NP-12-0001  
February 6, 2012

Subject: Exelon Nuclear Texas Holdings, LLC  
Victoria County Station Early Site Permit Application  
Response to Request for Additional Information Letter No. 14  
NRC Docket No. 52-042

**RAI 02.05.01-22:****Question:**

**Figure 1. Geologic Features of the Gulf Coast Region with the Locations of the October 20, 2011  $M_w$  4.8 and November 12, 2011  $M_w$  3.3 Earthquakes**

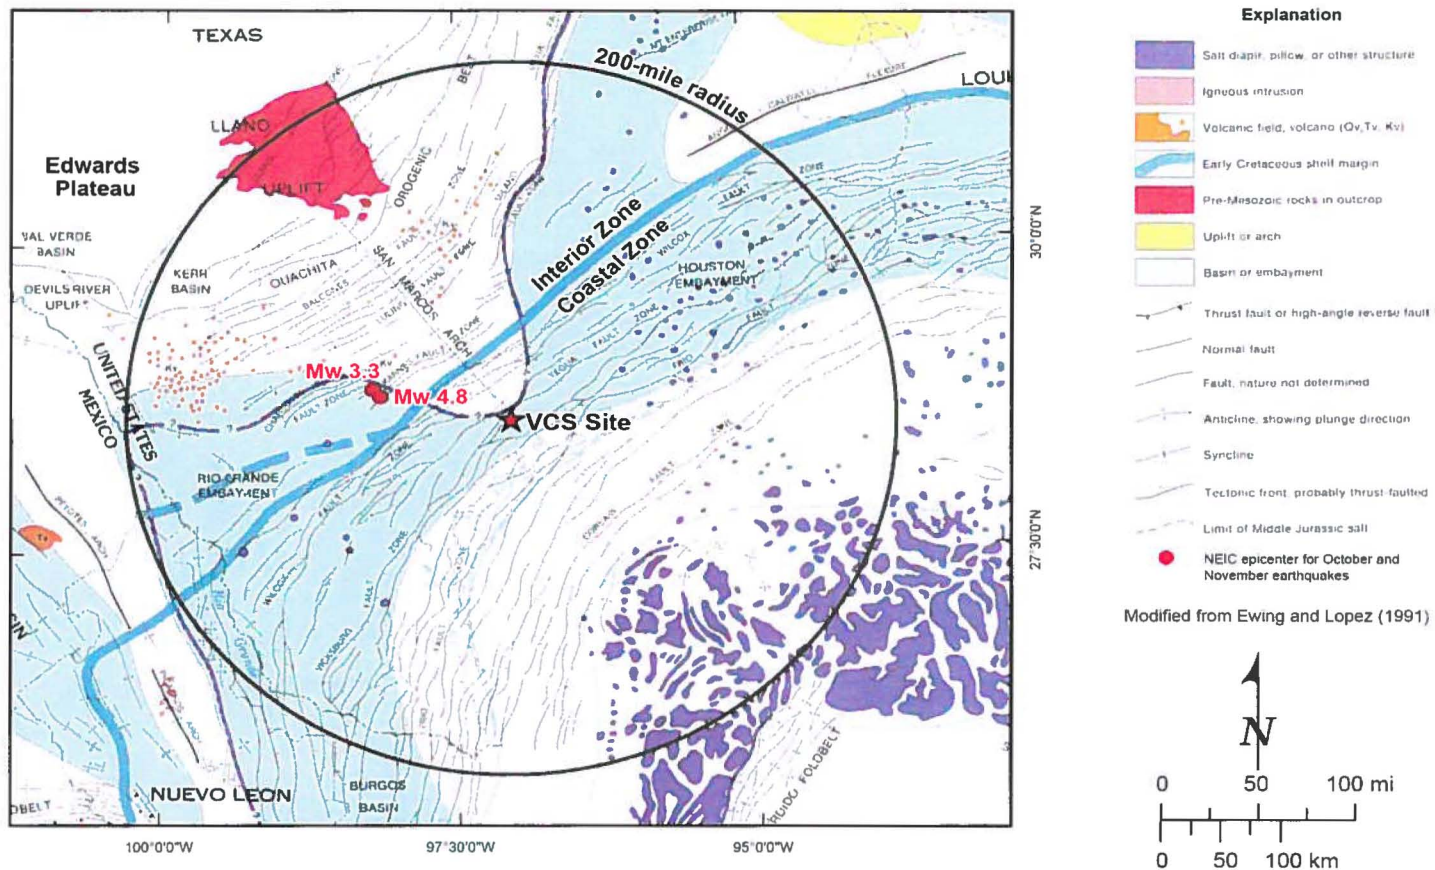
The USGS reported the Texas October 20, 2011 earthquake as a shallow (3 km, poorly constrained), Mw 4.8 earthquake with moment tensor solution of normal fault movement oriented northeast. The staff notes that both this earthquake and the November 12, 2011 Mw 3.3 event are located ~65 miles west of VCS, possibly near the surface expression of the Luling and Balcones fault zones. In order for staff to evaluate regional tectonic features within the 200 mile radius of VCS in its review of the VCS application and in support of 10 CFR 100.23, please provide the following:

Provide a discussion that examines the Texas earthquakes (October 20 and November 12, 2011) and implications for a VCS regional tectonic feature that might be considered a capable fault that originates within the Ouachita basement rock, beneath the Gulf Coast Coastal Plain sedimentary section. Include in your discussion the alternative possibilities that the Texas earthquake is induced or that it is a small seismic event on an active growth fault. Additionally, consider and discuss the possibility of an error in the location of the earthquake and the implications that a location error could have on all the above and related event fault and source interpretations.

The October Mw 4.8 and November Mw 3.3 earthquakes are located near Fashing, Texas, in an area of the Coastal Plain that has experienced several small to moderate earthquakes in the past approximately 40 years (Figure 1). As explained below, researchers studying past earthquakes in this area argue this seismicity is most likely induced by human activities (Davis, et al., 1995; Pennington, et al., 1986), and all information available suggests that the 2011 events are most likely induced by human activity as well.

The Mw 4.8 and 3.3 events are located along the western margin of the San Marcos arch adjacent to the Charlotte-Jourdanton fault zone (CJFS) and the Karnes fault zone (KFS) (Figures 1 and 2). As discussed in SSAR Subsection 2.5.1.1.4.3.3, the CJFS and KFS (along with the Mexia-Talco, Milano, and Mt. Enterprise-Elkhart Graben fault systems) are a part of the Mesozoic fault systems of the Gulf of Mexico region and are interpreted as being related to bodies of Jurassic salt at depth (SSAR Figures 2.5.1-11 and 2.5.1-12) (Ewing, 1991; Murray, 1961). In general, these fault systems are updip of, and sole into, salt pinchouts or welds, and motion on the faults is related to salt migration that formed the welds and pinchouts (Diegel, et al., 1995; Nelson, 1991).

Together the basin-bounding CJFS, KFS, and the Mexia-Talco fault zone are considered part of the "peripheral graben zone" (Ewing, 1991) and are 30 miles or more southeast of the Luling and the Balcones fault zones (Figure 1). The CJFS and KFS consist of a series of generally northeast-trending, *en echelon*, graben-bordering normal faults (Figures 2 and 3). Stratigraphic relationships suggest that fault movement began in the Jurassic and the youngest rocks displaced by these fault zones are undifferentiated Paleocene-Eocene strata, which is faulted at the ground surface (SSAR Figure 2.5.1-42) (Ewing, 1991). Documented evidence of Quaternary surface faulting is lacking in the Fashing area, but both fault zones are located within a zone of growth faults, defined by the margin of the San Marcos arc, in the USGS Quaternary fault and fold database (SSAR Figure 2.5.1-25) (Wheeler, 1999). Both the CJFS and KFS sole into salt at or just above Paleozoic Ouachita-age basement bedrock (Ewing, 1991; Pennington, et al., 1986). Depth to Ouachita basement in the Fashing region increases dramatically to the southeast because of the plunging San Marcos Arch structure. Depths to basement contours (SSAR Figure 2.5.1-26) suggest that basement is about 4 km below the November 12, 2011, epicenter, and about 5 km below the October 20, 2011, epicenter (Salvador, 1991). Cross sections presented by Pennington et al. (1986) illustrate that basement beneath the Imogene field and Fashing field are between 4.5 and 5 km deep in this area (Figures 3 and 4).

The October 20, Mw 4.8, and November, 12 Mw 3.3, Texas earthquakes were located approximately 70 miles west-northwest of the VCS Site near Fashing, Texas (Figure 1). The U.S. Geological Survey National Earthquake Information Center (NEIC) reports that the October 20, 2011, Mw 4.8 event was located at 28.806°N, 98.147°W—approximately one mile north-northwest of the town of Fashing, Texas, with an uncertainty of 12 miles (19.3 km) and an estimated depth of 1.9 miles (3 km) (with  $\pm 1.9$  miles [3.1 km] uncertainty; Figure 2) (USGS, 2011b). The double-couple focal mechanism for the Mw 4.8 event includes a generally northeast-oriented (053° and 241°) solution dipping either 72° south-southeast or 18° north-northwest.
